**Matters to Come Before a Meeting of the Board of Directors  
of Tarrant Regional Water District**

**To Be Held the 16<sup>th</sup> Day of May 2023 at 9:00 a.m.**

**SUBJECT:** Consider Approval of Change Orders with BAR Constructors, Inc. for the Kennedale Balancing Reservoir Yard Piping, Inlet and Outlet Modification Project

<b>Project:</b> <u>KBR Yard Piping and Inlet and Outlet Modifications (KBR3E)</u>	<b>Project Number:</b> <u>21-147</u>
<b>Owner:</b> <u>Tarrant Regional Water District</u>	<u>289</u>
<b>Contractor:</b> <u>BAR Constructors, Inc.</u>	<u>TWC2214</u>
<b>Engineer:</b> <u>Freese and Nichols, Inc.</u>

VERIFY SCALE	0	1
Bar is one inch on original drawing. If not one inch on this sheet, adjust scale.		
SHEET	CP-101	
SEQ.	161

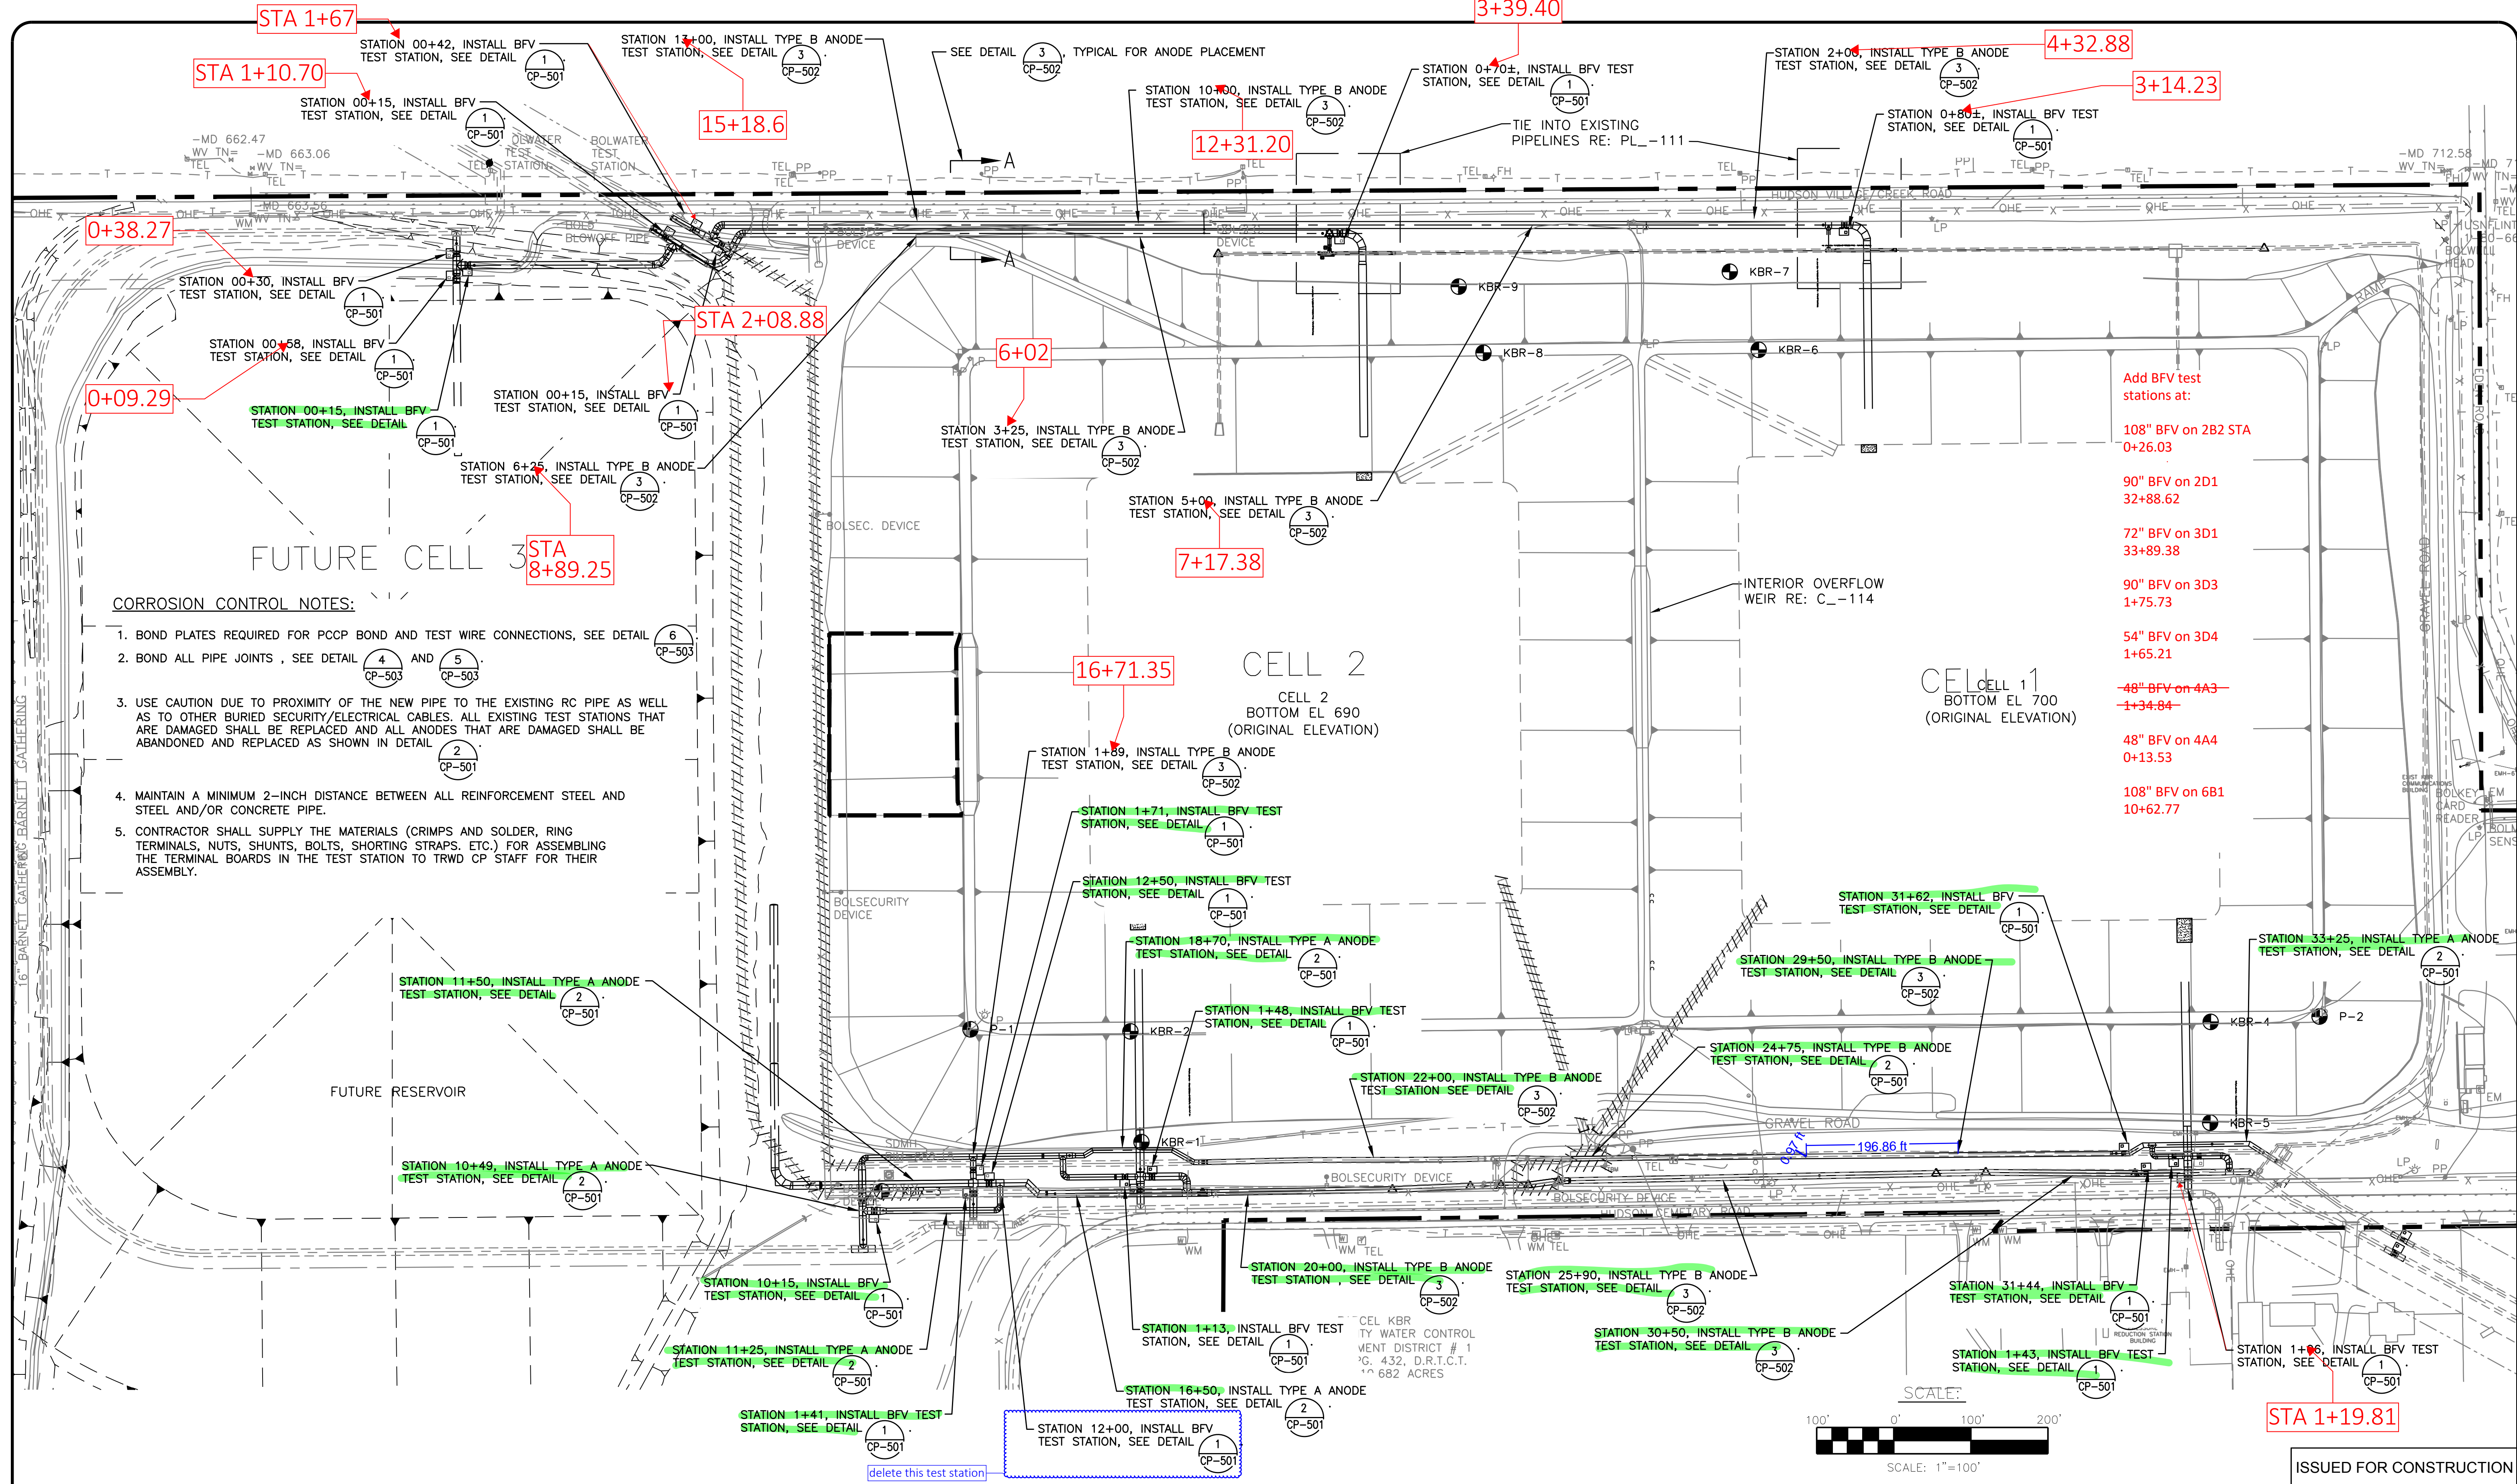
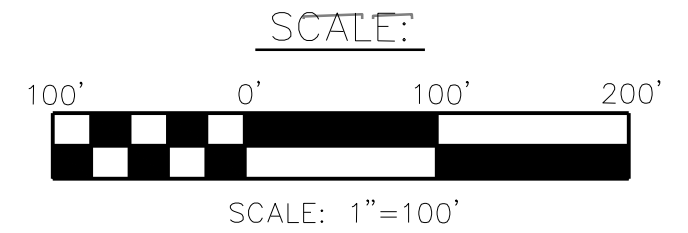
**Owner requests a Change Proposal for the following modifications to the Contract Documents:**  
Delete and add BFV test stations shown on sheet CP-101. See attached Description of Modifications.

On sheet CP-101:

- Modify stationing as marked up in the response to RFI-0021.
- Delete one BFV test station shown at Station 12+00 in area B (marked up on RFI-0021)
- Add eight BFV test stations at:
  - o 108" BFV on 2B2; Station 0+26.03
  - o 90" BFV on 2D1; Station 32+88.62
  - o 72" BFV on 3D1; Station 33+89.38
  - o 90" BFV on 3D3; Station 1+75.73
  - o 54" BFV on 3D4; Station 1+65.21
  - o 48" BFV on 4A3; Station 1+34.84
  - o 48" BFV on 4A4; Station 0+13.53
  - o 108" BFV on 6B1; Station 10+62.77

- Add BFV test stations at:
- 108" BFV on 2B2 STA 0+26.03
  - 90" BFV on 2D1 32+88.62
  - 72" BFV on 3D1 33+89.38
  - 90" BFV on 3D3 1+75.73
  - 54" BFV on 3D4 1+65.21
  - ~~48" BFV on 4A3 1+34.84~~
  - 48" BFV on 4A4 0+13.53
  - 108" BFV on 6B1 10+62.77
